Re: 513 Dice Street, Proposed location for new house on divided lot.

RE: 513 Dice Street (TM 29-63.1); BAR Deviation Request

PRELIMINARY SITE PLAN FOR
513 DICE STREET
CHARLOTTEVILLE, VIRGINIA
APPLICATION PLAN

SHEET
3
OF 4

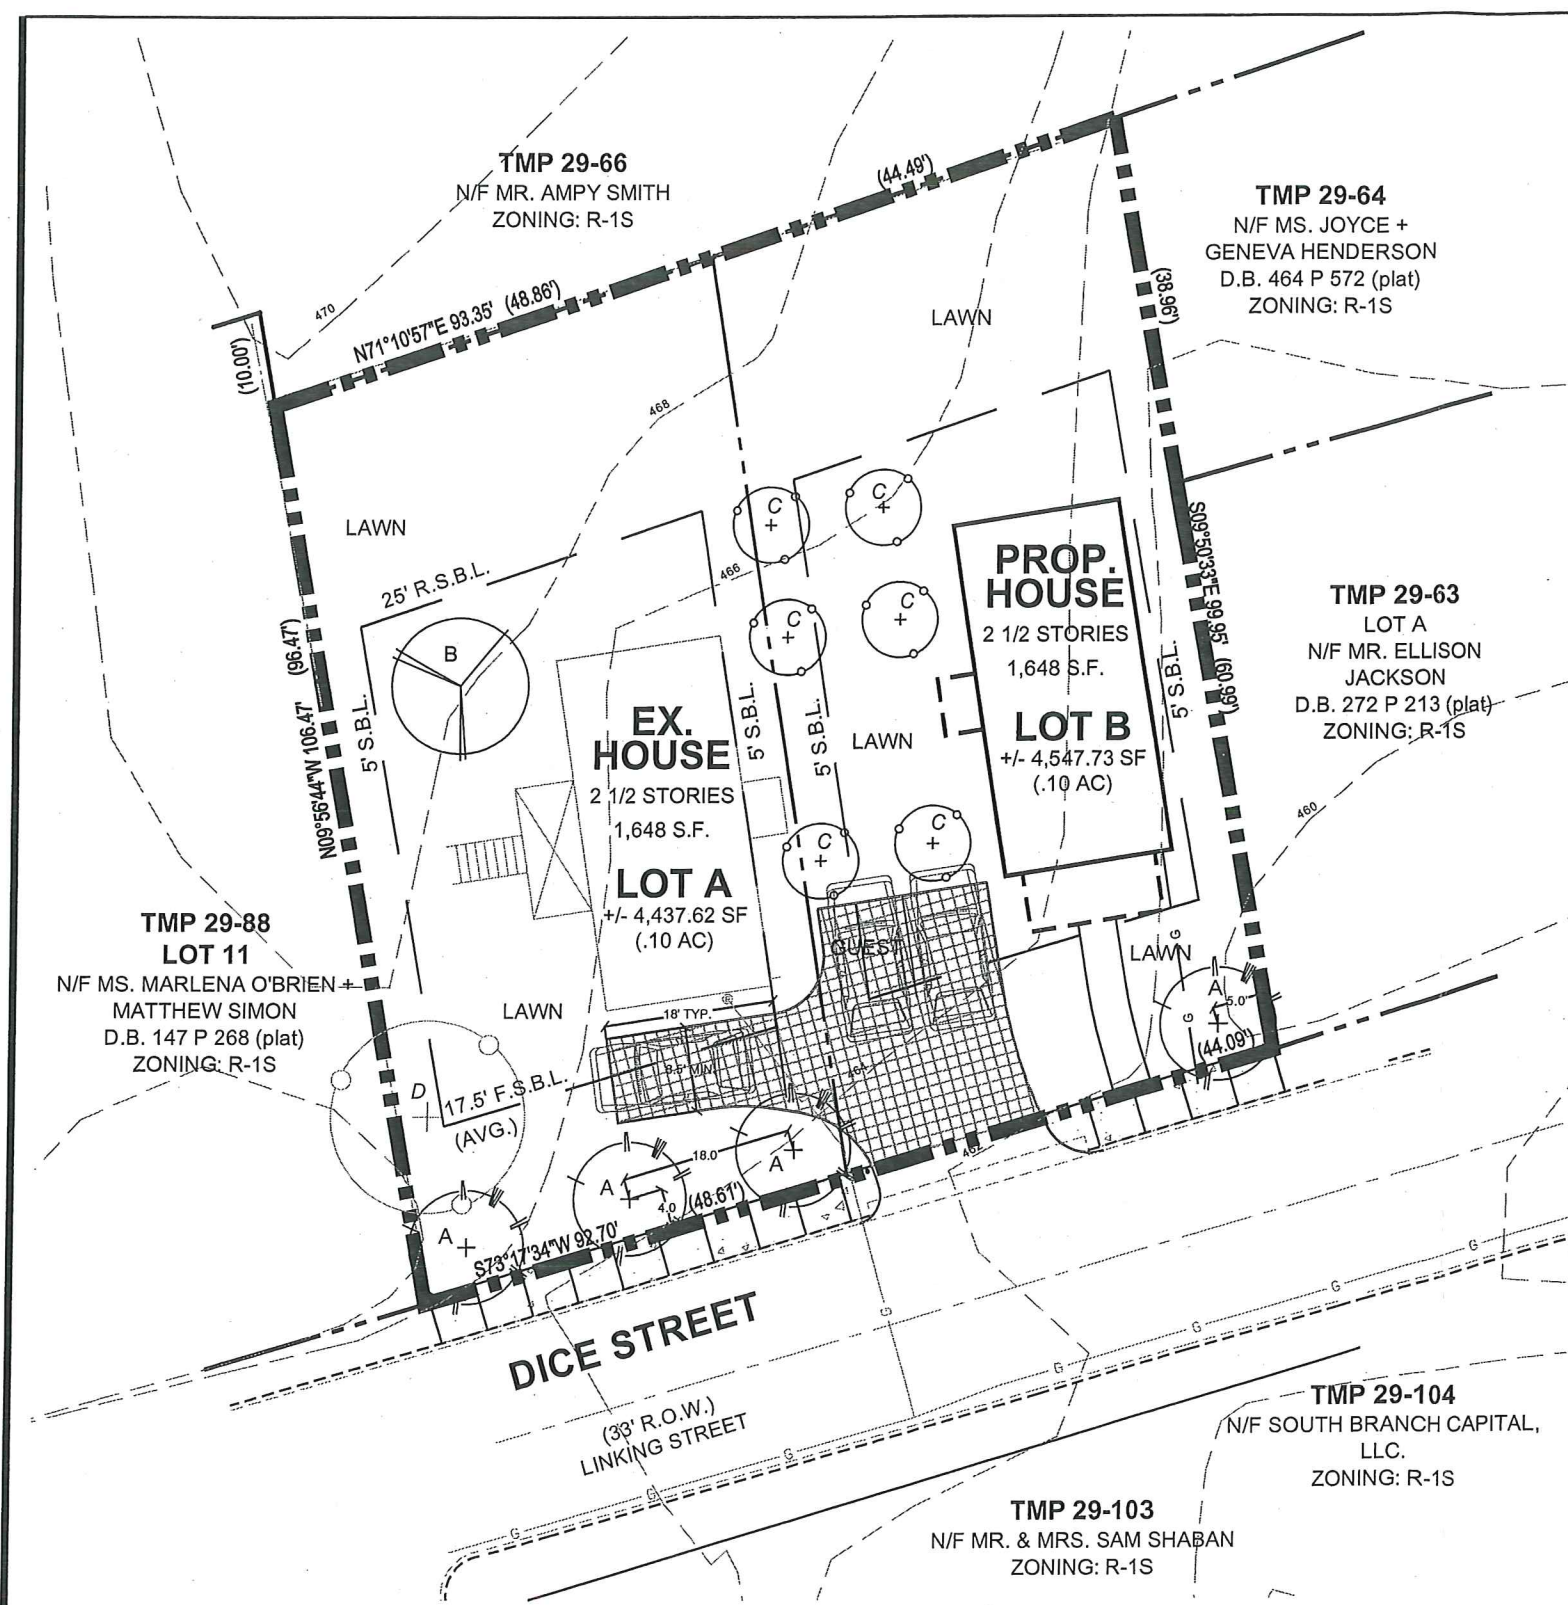
Jane called me this morning and she asked my opinion on the BAR letter to deviate from their recommendation. I told her that was fine, but after analyzing this application to write my staff report this week, I really think that this house should be pulled to the front of the site to better relate to the existing fabric which has buildings closer to the street and that the parking should adhere to the requirements of no more than 25% of the front yard. She seemed amiable to the idea.

About the current crab apple trees, there is nothing in our code that allows us to substitute current trees of less than 8' in caliper in lieu of planting new ones. Therefore, I would suggest relocating these trees to somewhere else on the site and planting 4 medium canopy tree of 2" at planting.

In regards to parking, try not to make more than 25% of the front yard of the new unit parking, unless it creates a better and more innovative arrangement. You can decide whether it behooves you keep the current paved parking or not. As long as our spaces meet our standards and the parking angles make sense you should be ok.

In your e-mail correspondence, you recommended that the house be pulled to the front of the site to relate to the existing neighborhood fabric. You also recommended that parking adhere to current zoning requirements of no more than 25% of the front yard.

We have amended our proposal to follow your recommendation and have enclosed a proposed site plan reflecting these changes. Similar to the existing house, the proposed house will also be two stories with a basement. The foot print of the proposed house will be no larger than the footprint of the existing house. The new home will have a front porch which addresses the street, an architectural feature typical of the neighborhood.
